# **UKWIN'S D4 COMMENTS ON REP3-040**

**REP3-040: DEADLINE 3 SUBMISSION -11.3 COMMENTS ON  
WRITTEN REPRESENTATIONS: PART 2 – OTHER INTERESTED PARTIES**

**Medworth EfW CHP**

**EN010110**

**Request for further elaboration of the implications of the Medworth Firing Capacity Diagram with regard to the link between NCV/thermal input and MW/MWh output (paragraphs 6 and 7).**

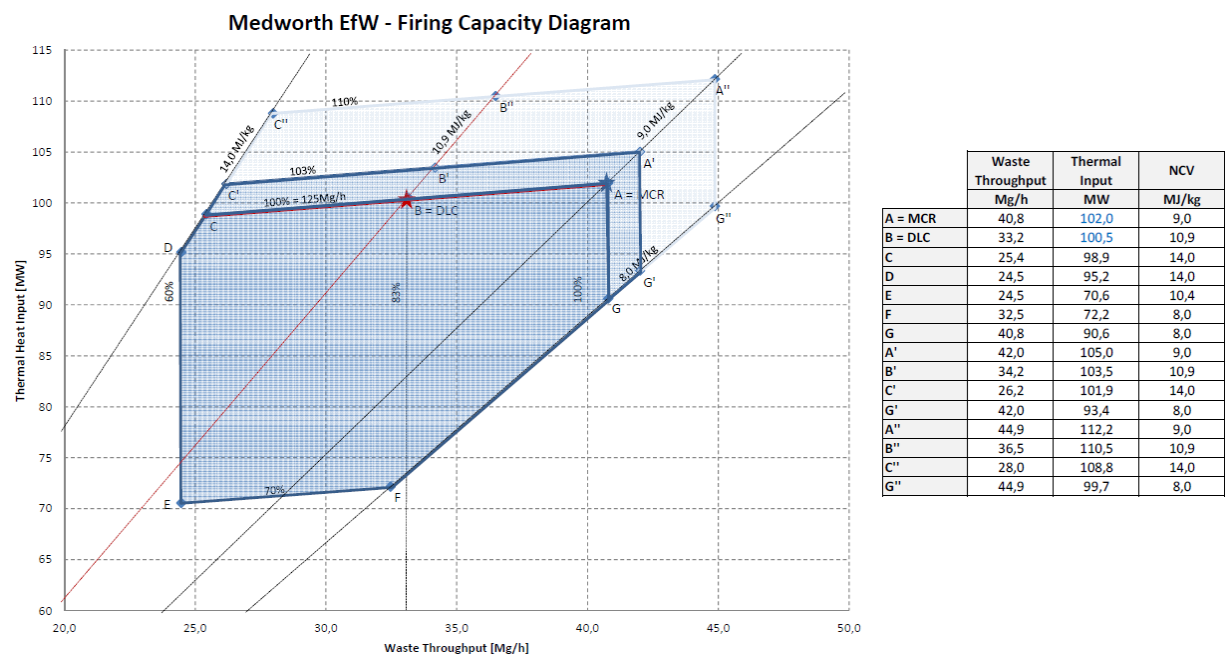
26. Despite UKWIN’s request, the Applicant’s response on internal pages 92-93 of REP3-040 does not actually set out the implications of the Firing Diagram with respect to the NCV inputs of 9.53, 9.50 and 8.85 at the fixed rate of input of 39.1Mg/h.
27. UKWIN did not ask for an explanation of how to read a capacity firing diagram. UKWIN requested the Applicant’s interpretation of their diagram and the Applicant’s explanation of the discrepancy between what the diagram indicates and what their climate change assessment modelled.
28. The Applicant provided the following diagram in Graphic 14.2 of APP-041 (Climate Assessment):

29. In REP3-040, the Applicant stated: “In Graphic 14.2 of ES Chapter 14: Climate Change (Volume 6.2) [APP-041], the line between point C and point A represents 100% steam production of 125 Mg/h. The facility is designed to operate at full load or 125 Mg/h steam production per stream (250 Mg/h combined) with any waste NCV between these two points and, since steam production is constant throughout this range, gross power production will remain close to 60 MWe throughout”. (emphasis added)
30. We take this to mean that when the waste throughput and thermal input falls below this line the plant would produce less than 100% steam and therefore not remain close to 60 MWe gross electrical generation. We have highlighted this narrow range of full output in fuchsia:

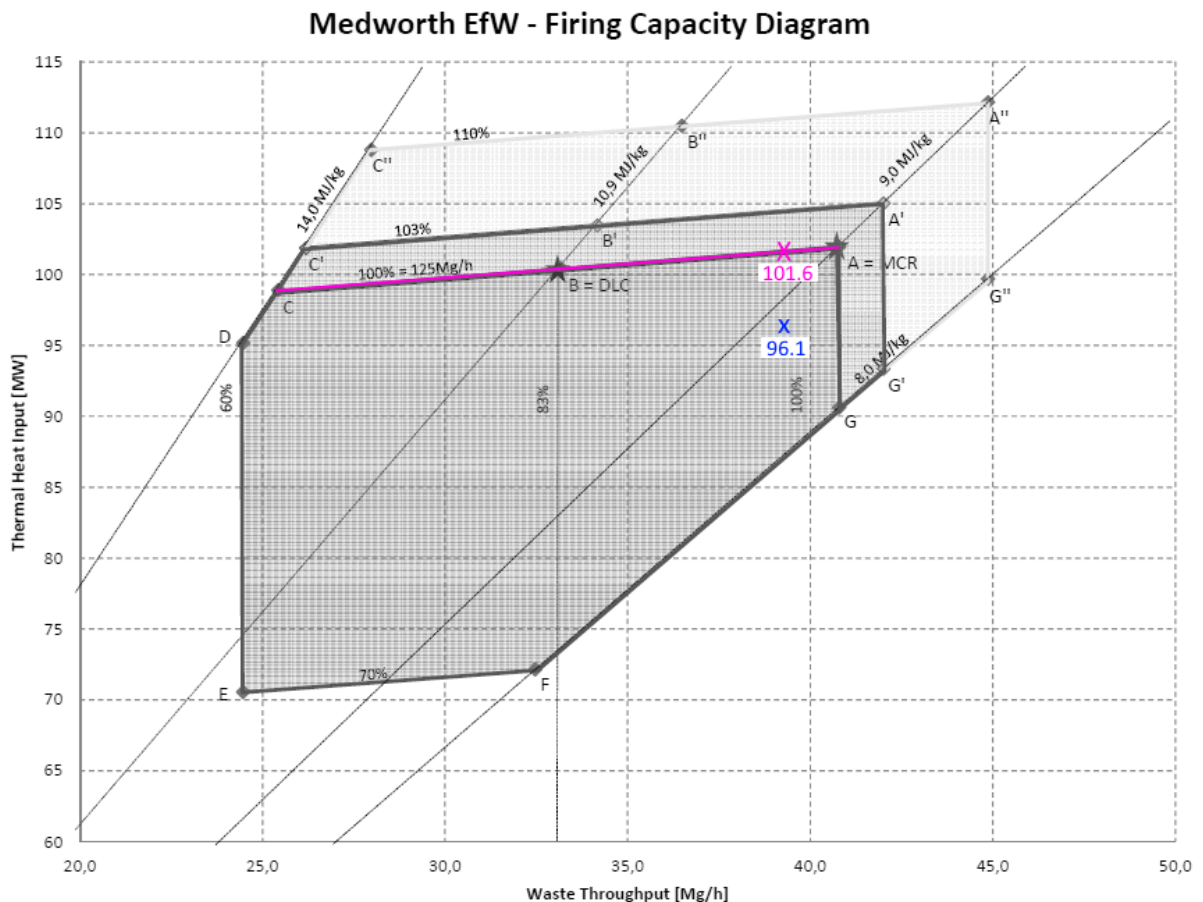
34. This allows for a comparison between the thermal input required for a 100% steam value at 39.1 Mg/h waste throughput and the amount of thermal input that would be produced by the reduced food and plastic case (also at 39.1 Mg/h), as shown in the following graph:

35. Assuming a linear relationship between thermal heat input and steam output at a given waste throughput, the fall from around 101.6MW to 96.1MW of thermal heat input can be expected to result in a fall in electricity generation from around 100% (60MW) to around 94.59% (56.75 MW).

36. This could mean that the plant might operate at significantly less than full output if the calorific value of the waste declines.
37. This therefore calls into question the Applicant's assumption about how much waste they could generate from 625,600 tonnes of waste at an NCV of 8.85 when operating for 8,000 hours.

38. Alternatively, to produce around the full output using a waste feedstock composition matching the reduced food & plastic case, the plant would actually need to treat around 660,000 tonnes per annum of waste rather than around 625,000 tpa.
